**Subject:** Fuel Tank strategy and Auxiliary Tap upfit interface

**Models Affected:** Chevrolet Silverado 4500HD, 5500 HD and 6500 HD

## ADVISORY:

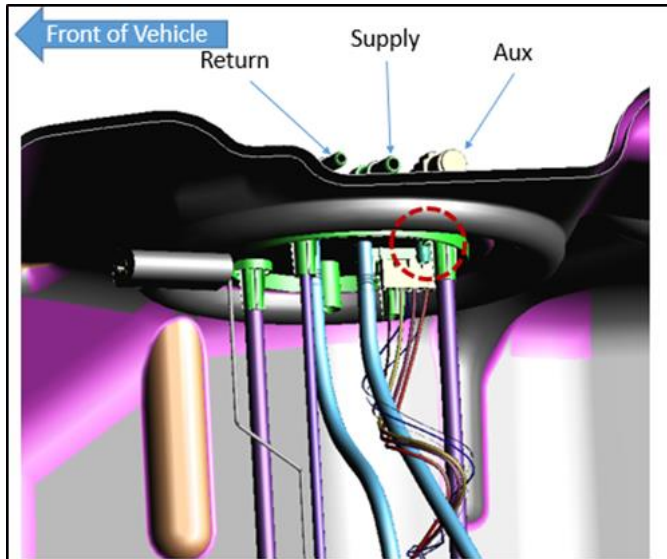
- The forward port (circled in red) (Fig. C) has no connection and could be used for return, however there is no draw tube connected as-is. Reefer installation guides recommend a return tube to drop down into the tank (as most of our engines require), presumably to prevent a siphoning effect. If the drop-down return tube is not mandatory the upfitter can connect to this port, otherwise the fuel delivery module can be removed, and a nylon tube pressed onto the internal fir tree nozzle inside of the tank. Nylon tube should be secured so that it doesn't interfere with float arm.

**40 Gal 'Aft' Tank(Single) RPO-N2L (Nav15SZN) Fig. D**

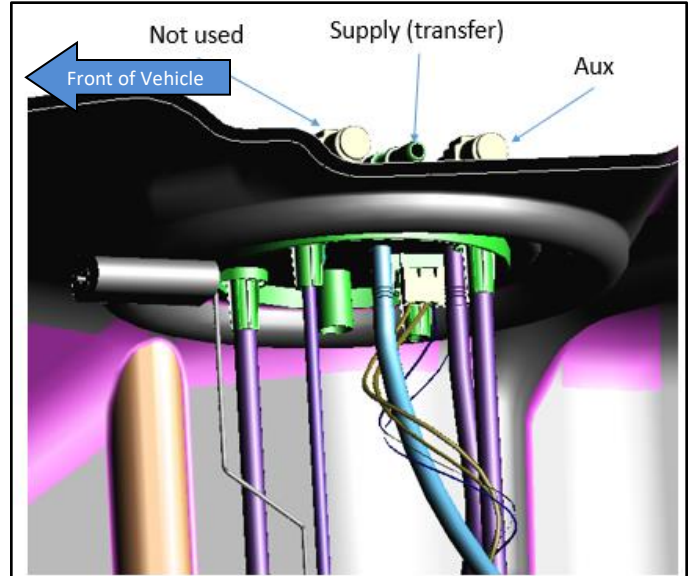
No OEM Draw Tube, a nylon tube can be installed to fir tree nozzle to allow fuel to be drawn from Aux Port. Suggested tube depth 30 mm from bottom of tank.

**25 Gal 'Mid' Tank(Single) RPO-NVK (Nav15SZP) & 40 Gal 'Aft' Tank(Dual) RPO-NSQ (Nav15DSZ) Fig. E**

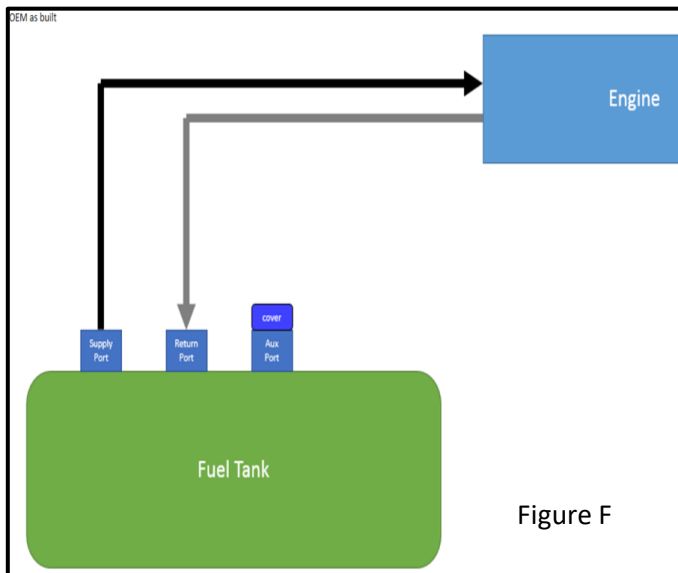
OEM installed Draw Tube, draws from Aux Port without modification.
